Stakeholder comment to the PAC re Asset Condition projects presentation

The “high-level view” fails to see the people on whose land these projects are built, and the land itself.
X-178 line July 2023

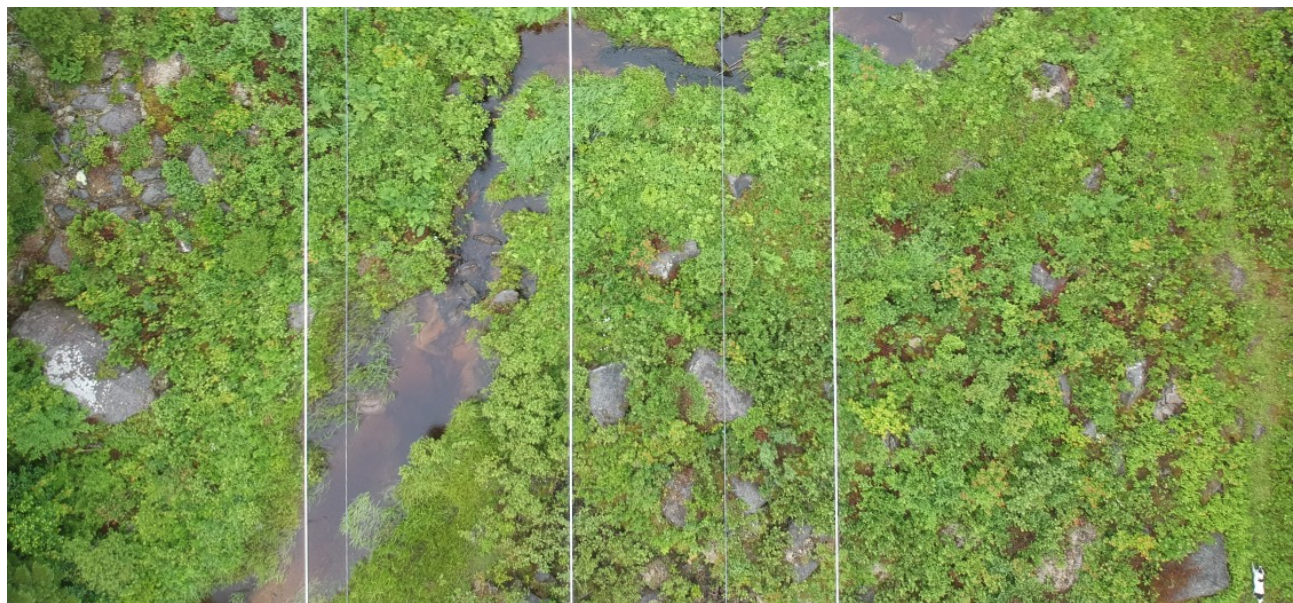
Stark O-154 line before “Asset Condition” rebuild:

Stark O-154 line August 2023 after “Asset Condition” rebuild; 336 conductor replaced with 1272 conductor, new wider and taller steel structures, Optical Ground Wire (OPGW), 100’ x 100’ construction ‘pads’, new roads left in place and massive importation of gravel.

The ‘left’ side of the easement is occupied by the Portland Natural Gas Transmission line thus not subject to the extensive alteration of the terrain to which the ‘right’ side has been permanently subjected.
